Ecology Response to Section 92 Questions for a Proposed Subdivision 2127 Kaipara Coast Highway, Makarau

Contract Report No. 5807b

March 2024

As part of the consenting process, Auckland Council issued a Request for Further Information (RFI) to the client under Section 92 of the Resource Management Act. This included questions relating to ecology, and the client has engaged Wildland Consultants Ltd (Wildlands) to provide additional information in response to the RFI.

Appendix 2. Vegetation and habitat types at 2127 Kaipara Coast Highway, Makarau

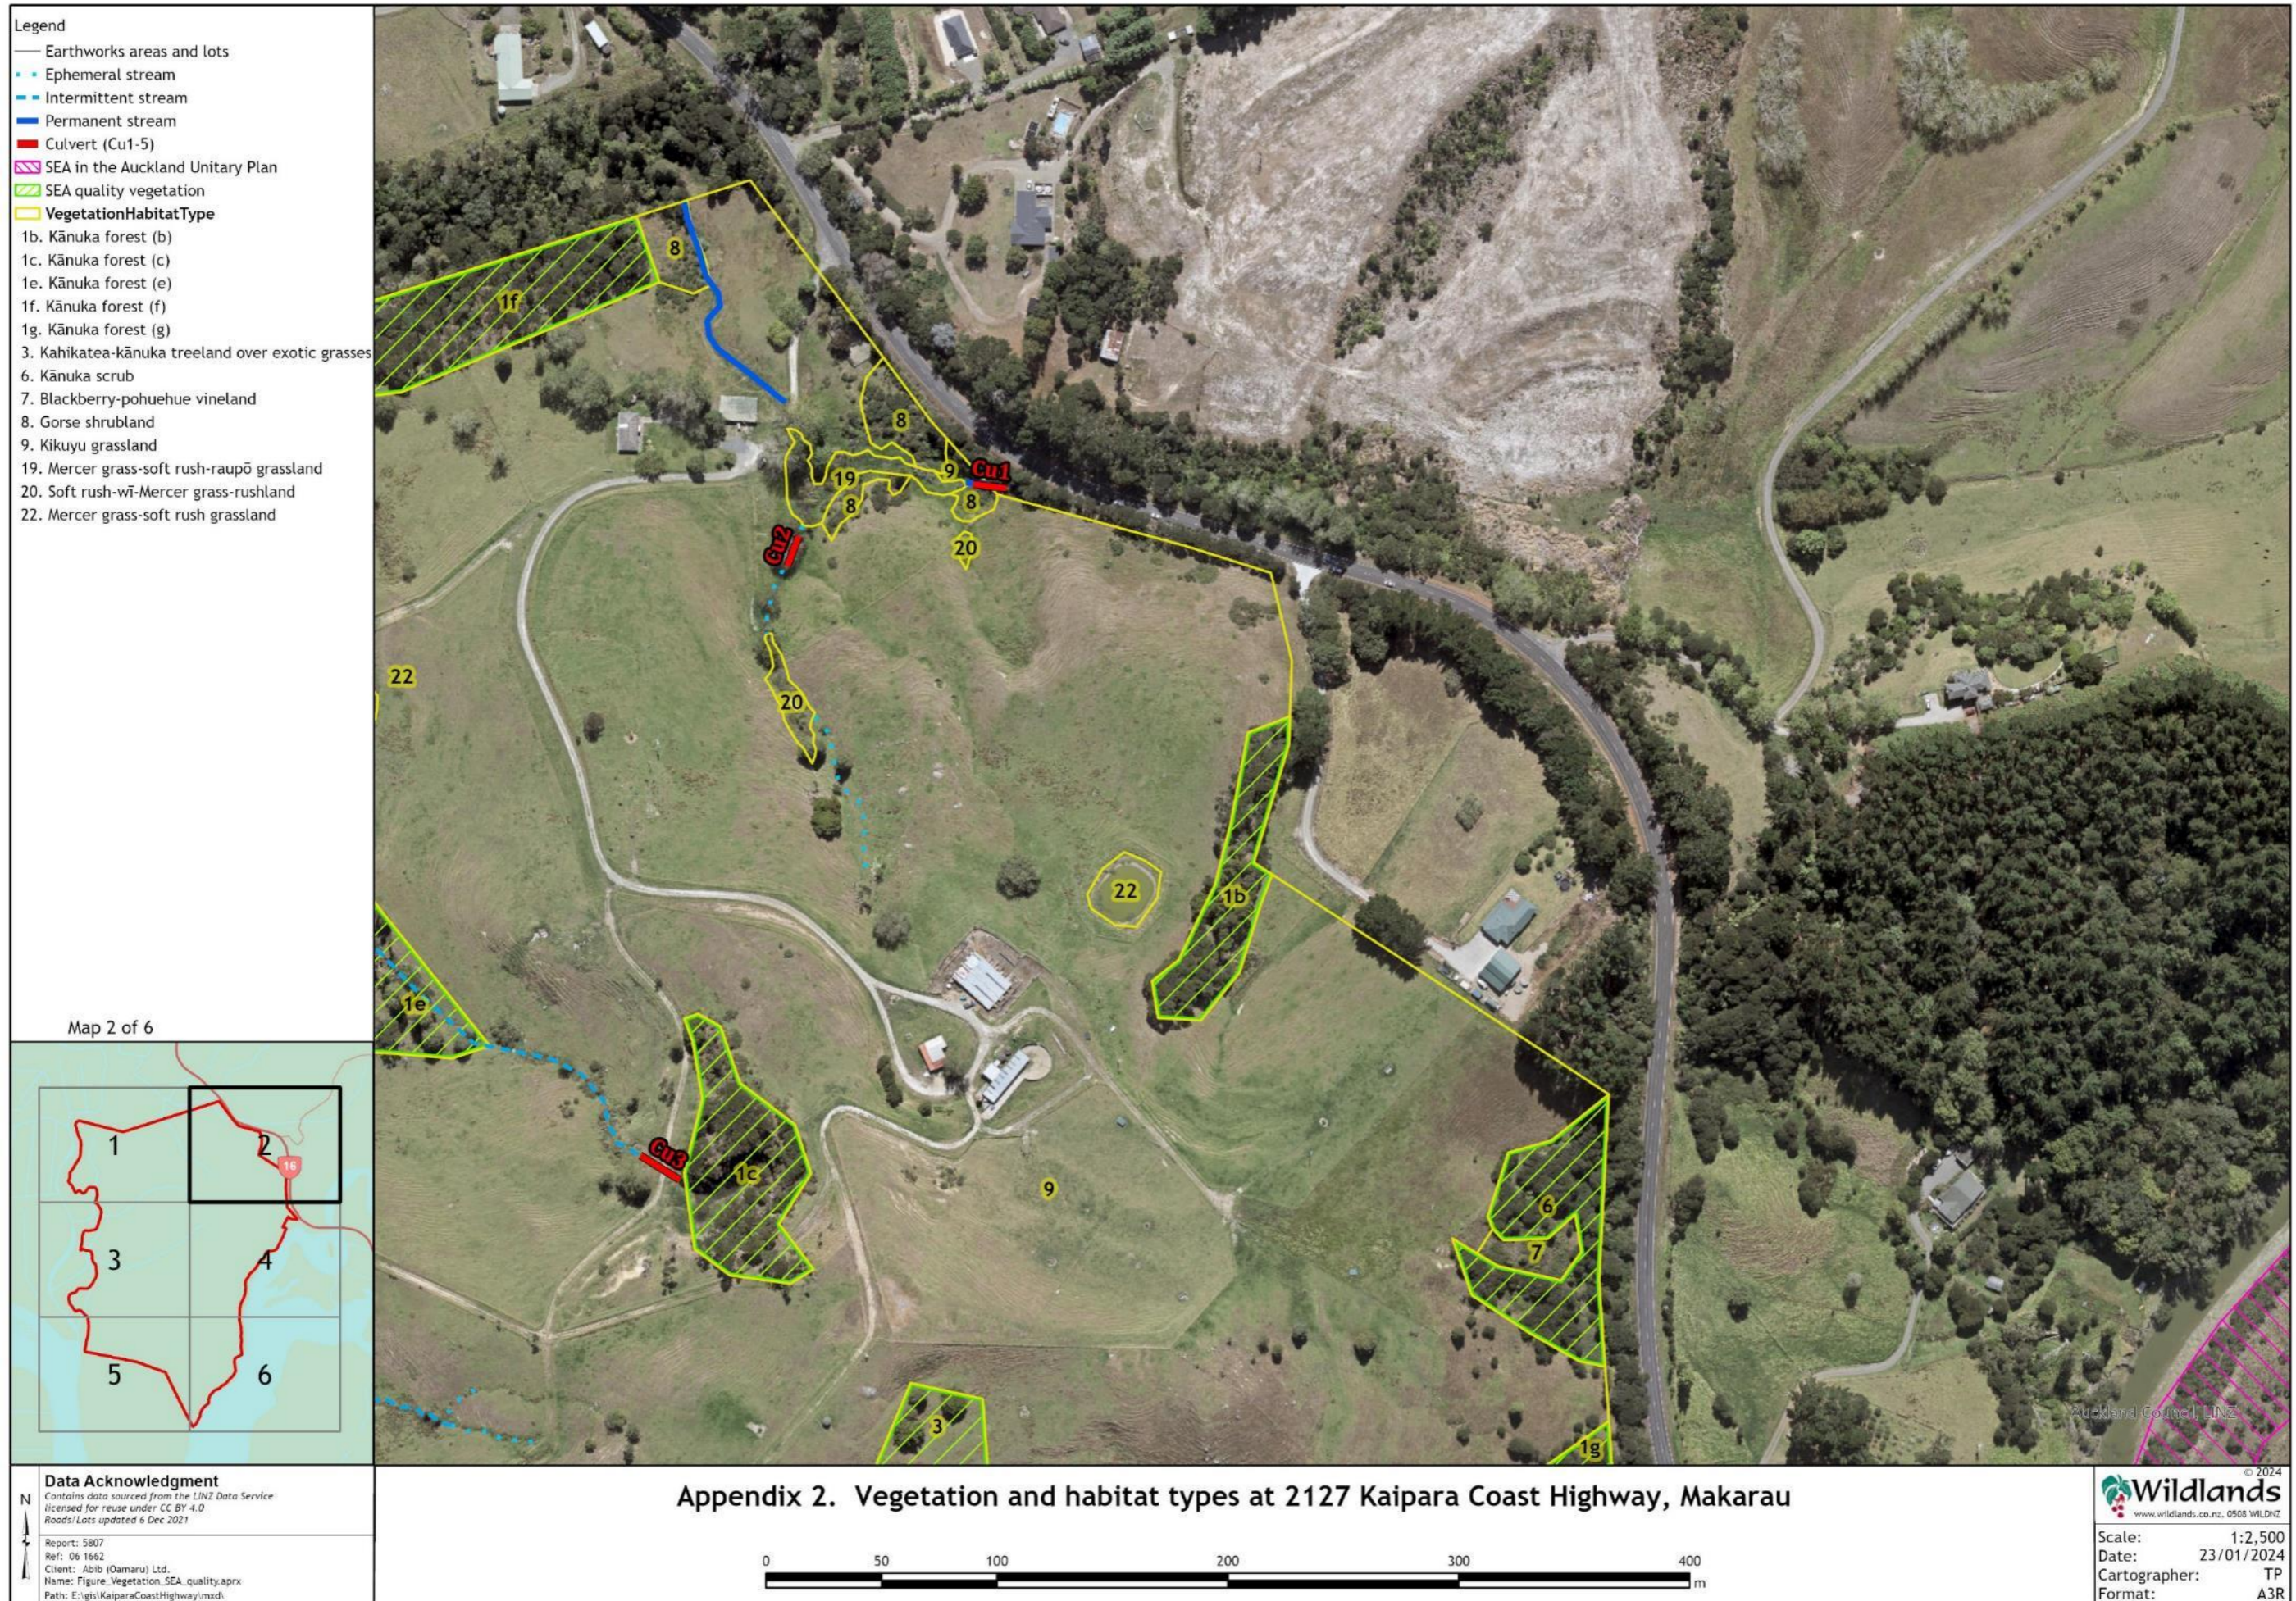
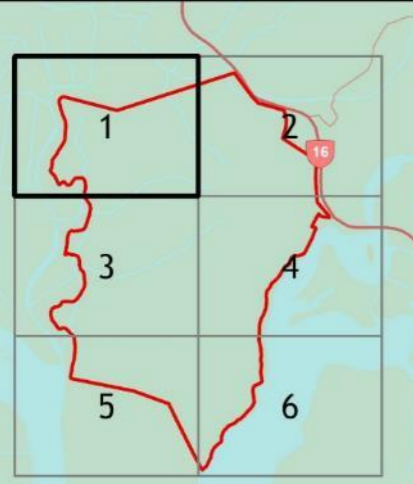
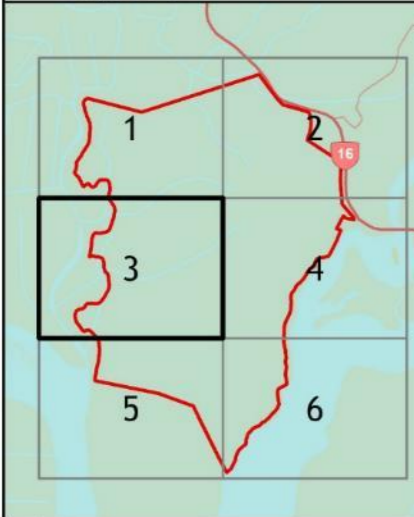
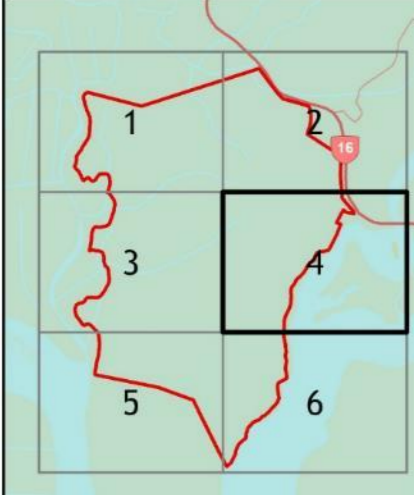
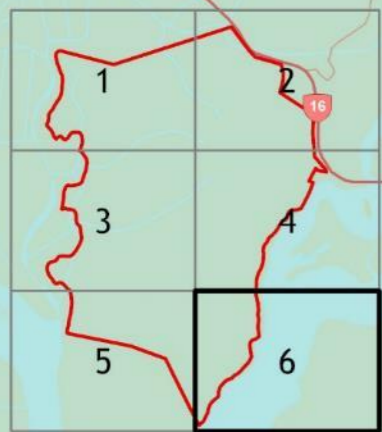
A plan is requested as per E39.6.1.6 clearly identifying SEA areas and other areas of indigenous vegetation, wetlands, and watercourses on site.

Please provide an assessment of areas of vegetation proposed for protection that are already identified as SEA or areas meeting the factors for Significant Ecological Areas in Policy B7.2.2(1) and confirm the areas (m²) each of the areas within the site cover.

The maps provided in the original Ecological Impact Assessment (EclA) have been updated to include the SEA overlay and any areas that are of 'SEA Quality' (Appendix 2). As outlined in the EclA, this includes all areas of forest, treeland, and scrub at the site as they are likely to provide habitat for indigenous fauna species that have been classified as 'Threatened' or 'At Risk' (Factor 2b: Threat status and rarity). These fauna habitat values are discussed in more detail in Section 6 of the EclA. These vegetation types also form part of a network of sites that cumulatively provide important habitat for indigenous fauna (Factor 4c: Stepping-stones, migration pathways and buffers).

All natural inland wetland areas that are dominated by indigenous plant species also meet the criteria to be classified as SEA (Factor 2d: Threat status and rarity) and have therefore been mapped accordingly (Appendix 2).

All areas of SEA and SEA quality vegetation are proposed to be protected.

Revised map of Wetland 11

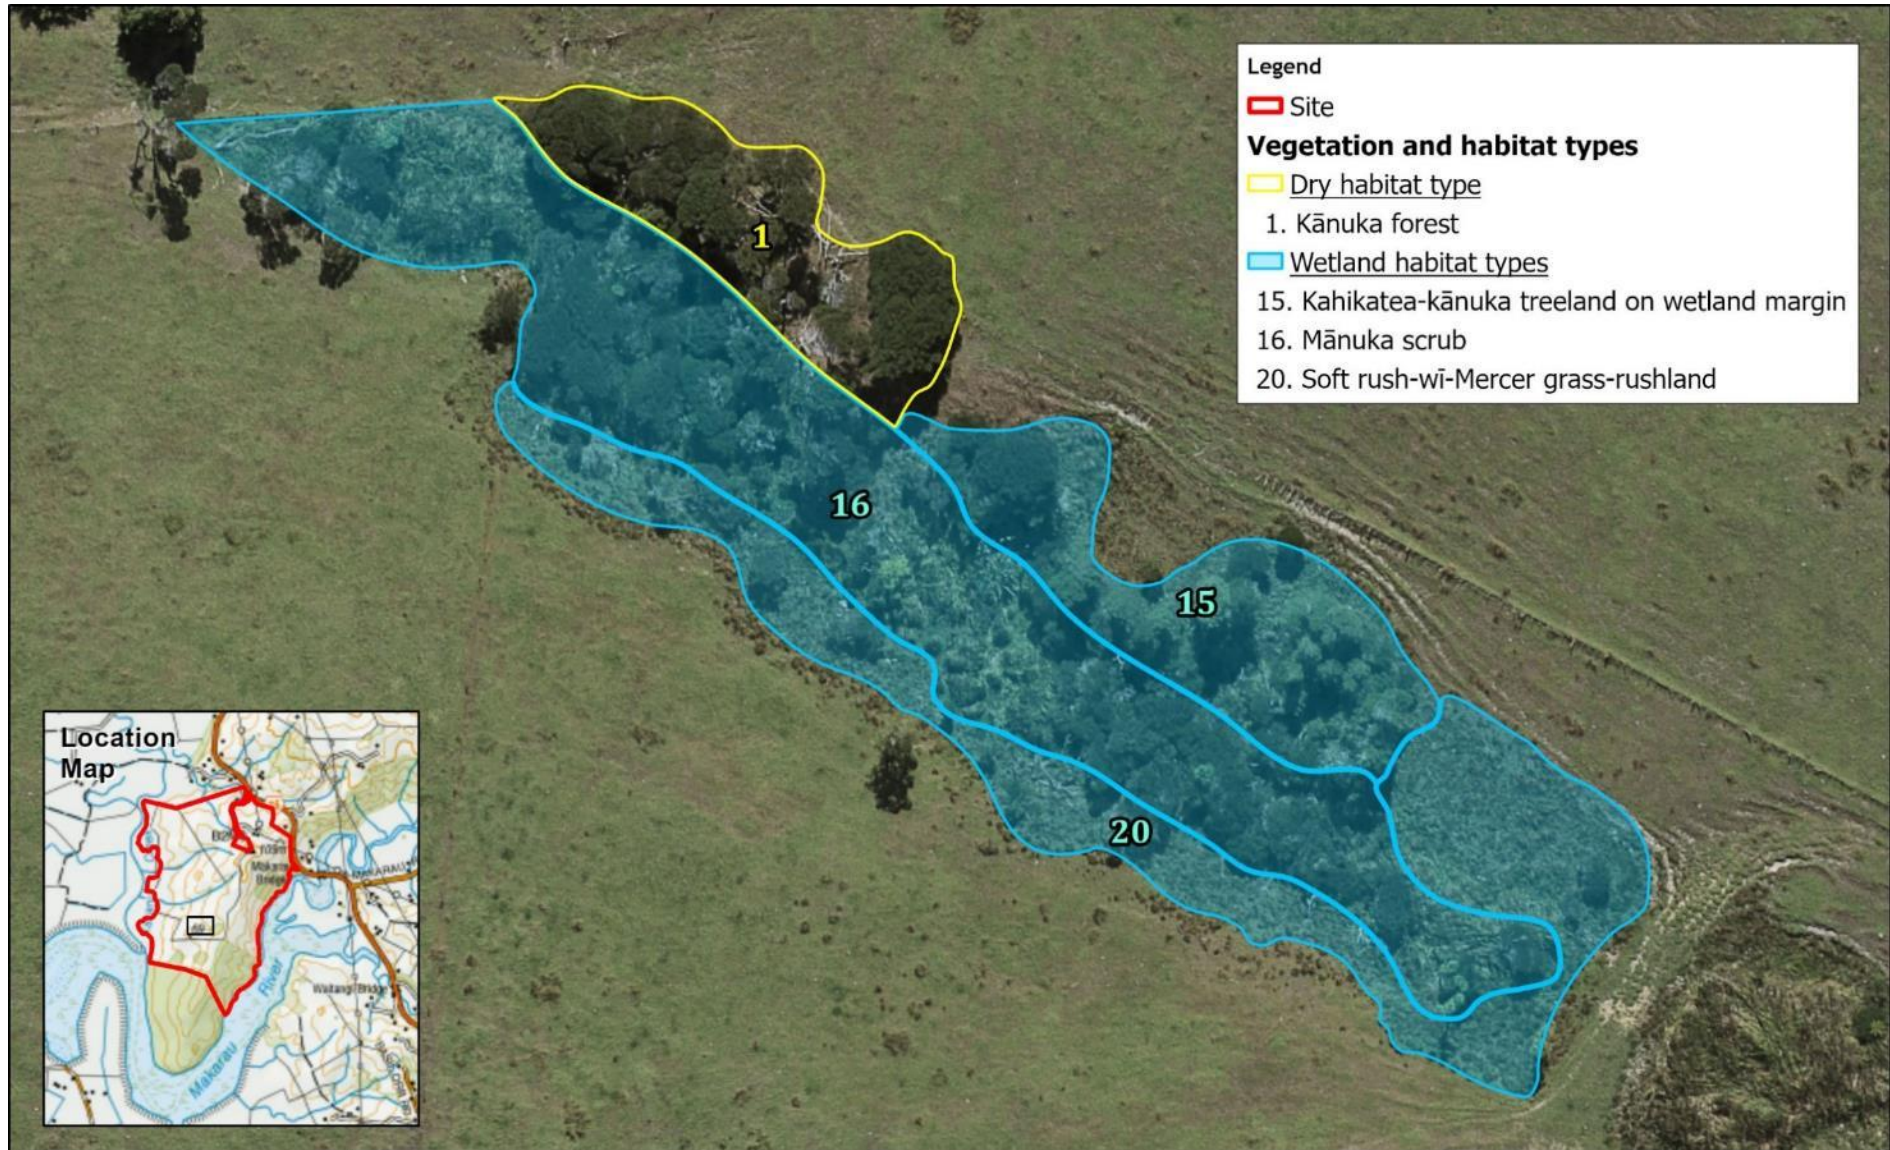
While most of the vegetation appears to be correctly mapped there are some areas that a greater area is covered as mapping is shown at a coarse scale. One location noted is on the southern edge and northeastern end of wetland 11 (areas 15 and 16 in the ecological assessment) where wetland rushes are located beyond the mapped area. Correct vegetation extent is especially important in the case of wetlands where wastewater dispersal fields are proposed in proximity to these to ensure required offset is provided. Please provide updated plans and information.

Wetland 11 was revisited on 11 December 2023 to reassess the boundary. A revised boundary map has been provided (Appendix 3). While some areas of scattered rushes fall outside of the new mapped boundary, these are much sparser than within the wetland area. As such, the pasture grasses and herbs continue to be dominant in the areas that have been excluded.

Ground conditions were also considered during the assessment, with the soil within the wetland area being damp to saturated, while outside of the new boundary it was dry.

There are differences between the new boundary and that shown in the original report. However, these are minor and they extend in both directions (i.e., in some areas the new line goes out, and in others it goes in from the original boundary). The largest change is the reclassification of a small area of kānuka as a dryland habitat.
